Omni Waste of Osceola County, LLC
1501 Omni Way
St. Cloud, Florida 34773

**MINOR MODIFICATION
APPLICATION FOR CELL 3 AT
OAK HAMMOCK DISPOSAL FACILITY**

Project Number FL0866/05

May 2006

Figure 2

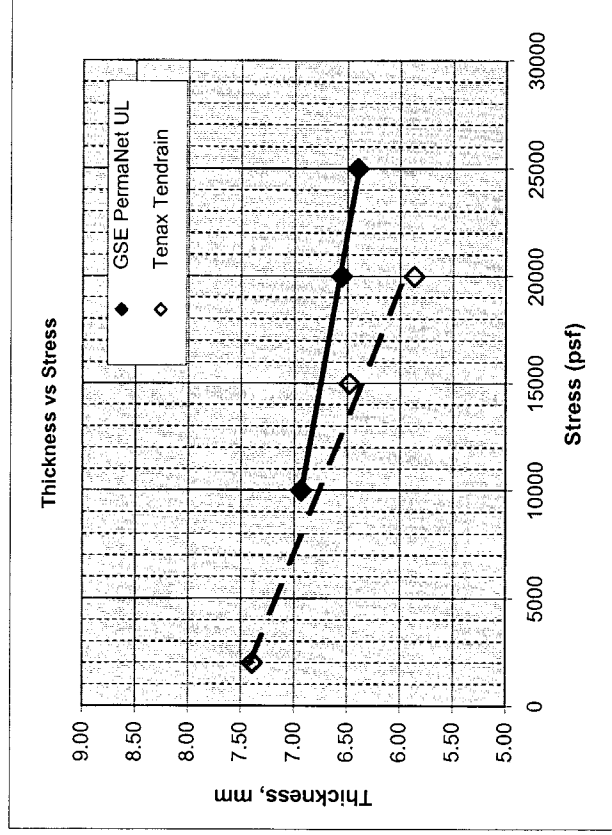
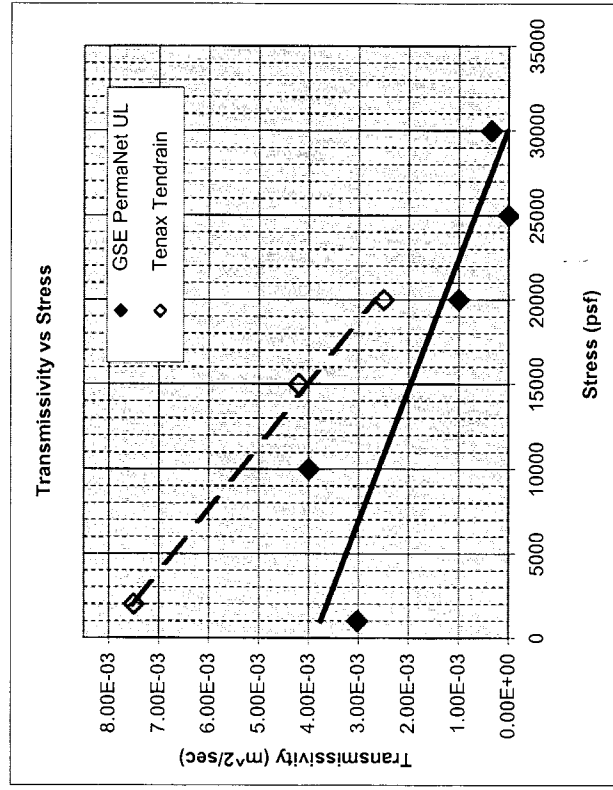
A comparison between the primary properties of Tenax Tendrain and GSE Permanet UL geocomposites is presented in Figure 2. As noted, the GSE Permanet UL geocomposite has slightly lower transmissivity as compared to the Tenax Tendrain triplanar geocomposite. However, the GSE Permanet UL geocomposite has higher resistance to creep in comparison to the Tenax Tendrain triplanar geocomposite, especially under high stresses. Since the transmissivity of the GSE PermaNet geocomposites is slightly lower than the transmissivity of the primary drainage geocomposite required by the current technical specifications (see Section 02740, Appendix P of the May 2002 Permit Application), this minor modification application is proposing an additional leachate collection drain in Cell 3 so that the maximum head on the primary geomembrane does not exceed 12 inches (as required by the regulations).

CURRENTLY PERMITTED LEACHATE COLLECTION SYSTEM IN CELL 3

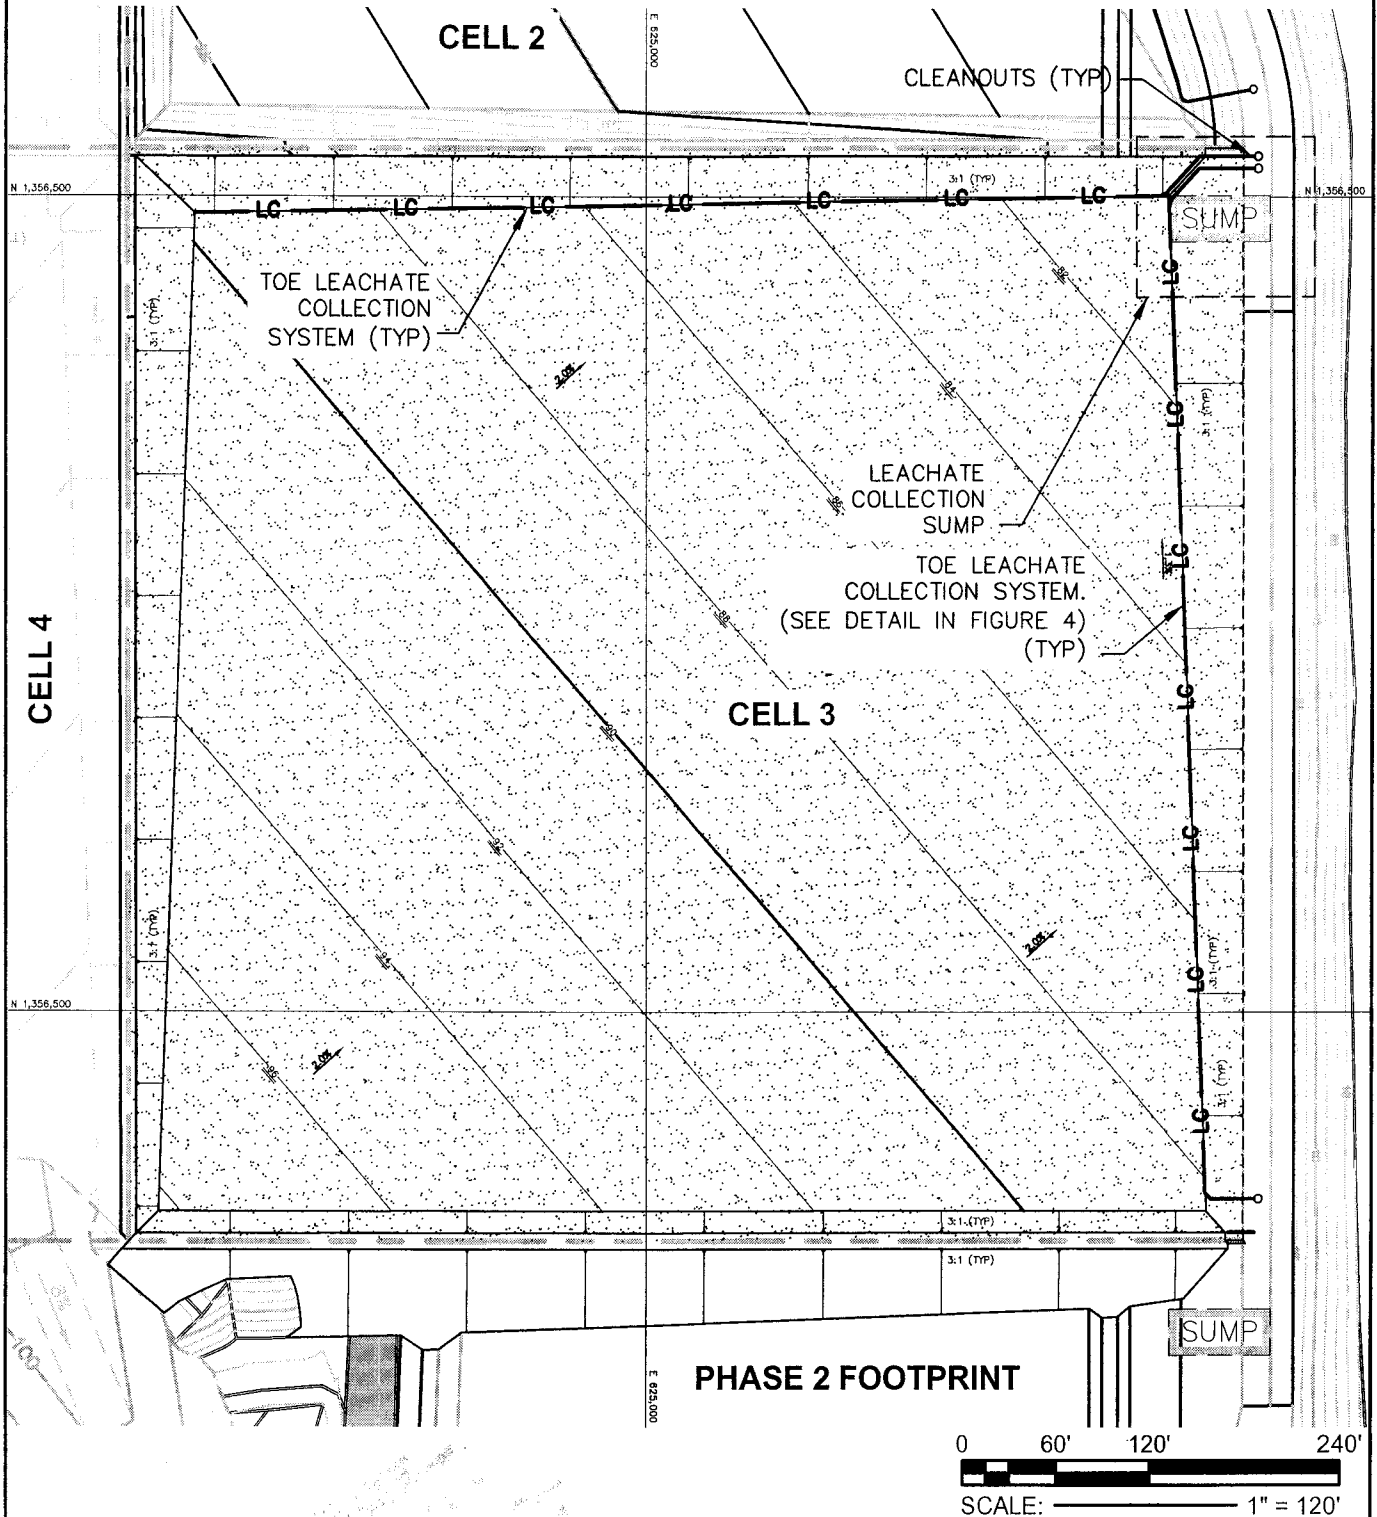
The currently permitted leachate collection system in Cell 3 is indicated in Figure 3. As noted, the currently permitted primary leachate collection system includes leachate collection drains along the north and east toe of Cell 3, which are referred to as the *toe leachate collection drains* in this minor modification application. The toe leachate collection drains consist of a 6-inch diameter SDR 11 HDPE perforated pipe surrounded by gravel and geotextile filter fabric as indicated in Figure 4.

PROPOSED LEACHATE COLLECTION SYSTEM IN CELL 3

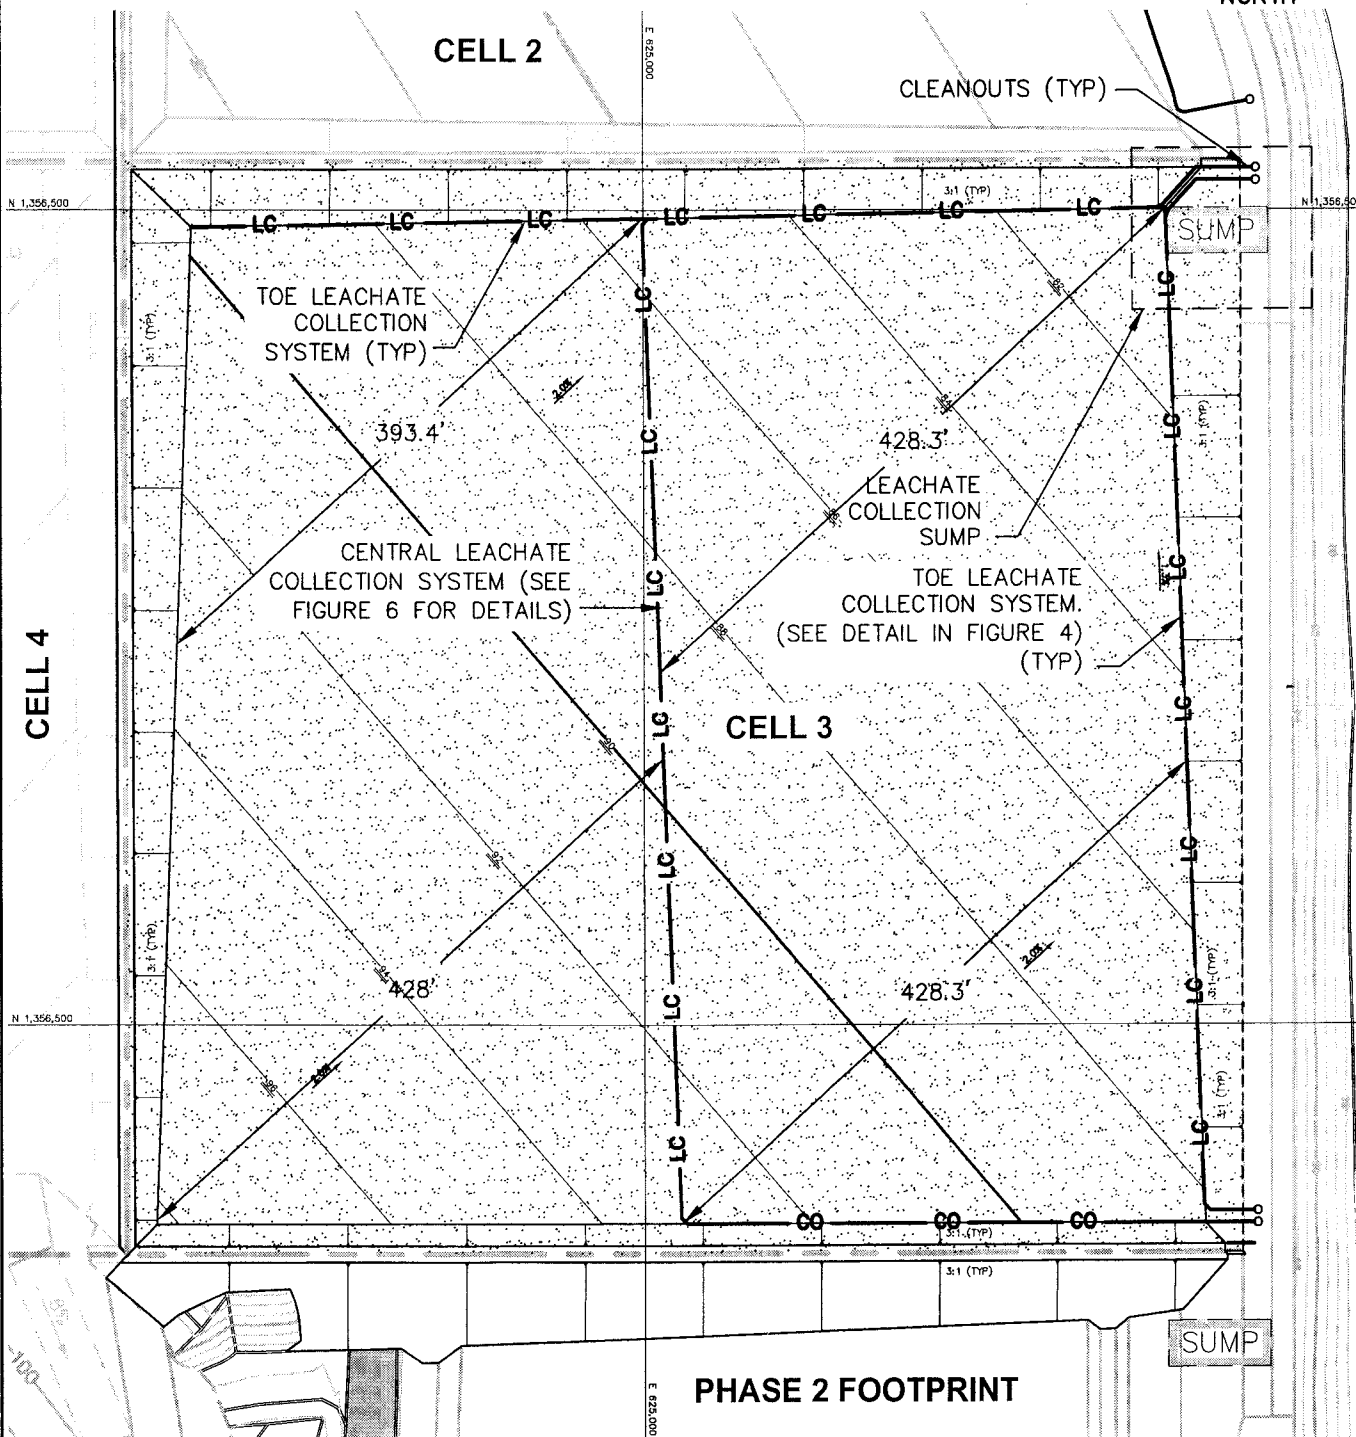
The proposed design modification includes providing an additional leachate collection drain in the center of Cell 3 as indicated in Figure 5, which are referred to as the *central leachate collection drain* in this minor modification application. As noted in Figure 5, the central leachate collection drain is located such that the longest drainage path in Cell 3 for the proposed design is approximately half that of the currently permitted design. A reduction in the longest drainage path for Cell 3 leachate collection system will allow use

An analysis was performed to evaluate the performance of the proposed central leachate collection system pipe that will be installed in Cell 3 (see Figure 5 of the minor modification application). A 6-in diameter perforated HDPE having a standard dimension ratio (SDR) of 11 will be used in the proposed central leachate collection system in Cell 3 (see Figure 6 of the minor modification application).

LEACHATE COLLECTION DRAIN IN CELL 3

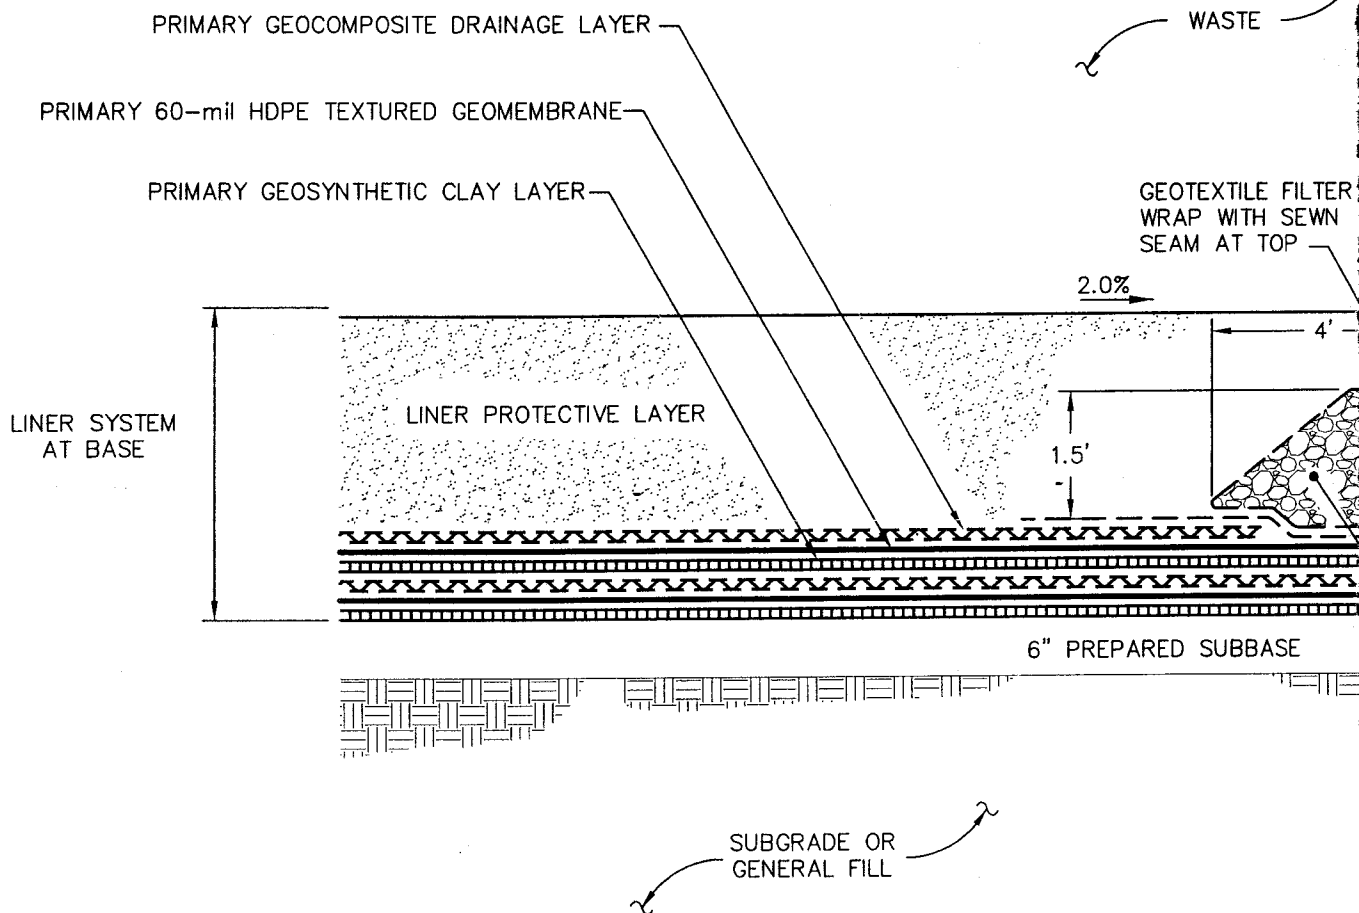
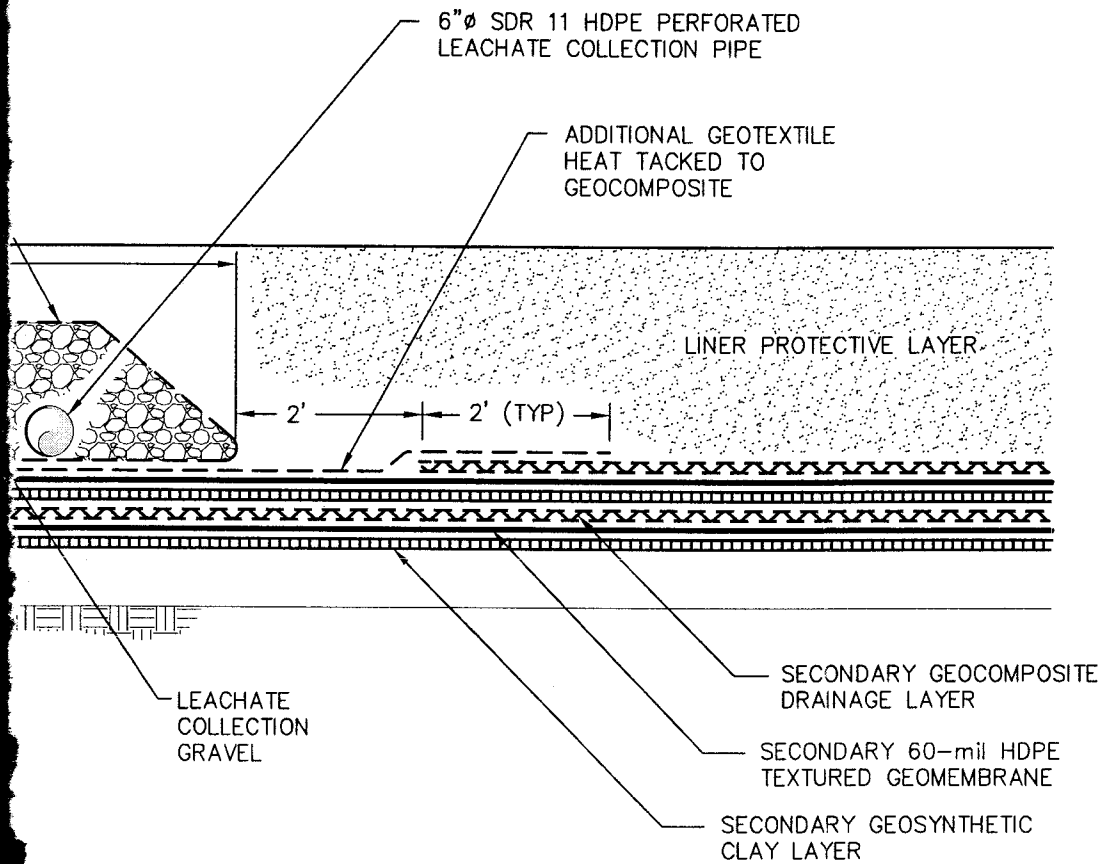
The proposed central leachate collection drain will consist of a 6-inch diameter SDR 11 HDPE perforated pipe surrounded by gravel and geotextile filter fabric as indicated in Figure 6. The size and layout of the perforations for the central leachate collection drain pipe will be same as that for the toe leachate collection drain pipe (see Sheet 19 of 50 of the Permit Drawings). The primary geocomposite drainage layer will be discontinued at the central leachate collection drain to force the leachate collected in west half of Cell 3 into the central leachate collection drain. To protect the ends of primary geocomposite drainage layer on either side of the central leachate collection drain, an additional geotextile will be overlapped and tack welded to the surface of the primary geocomposites as indicated in Figure 6.

The peak daily leachate generated in the Cell 3 was estimated to be approximately 218 gpm (Table C-1). Due to the proposed configuration of the central leachate collection system in Cell 3, the maximum percent of flow that the proposed central drain pipe is likely to receive is 50 percent of the total Cell 3 flow. Therefore, the design flow for the proposed central drain pipe is approximately 109 gpm. The proposed central drain pipe is a 6-in diameter SDR 11 HDPE pipe that slopes at approximately 1.2 percent (see Figure 6 of the minor modification application).
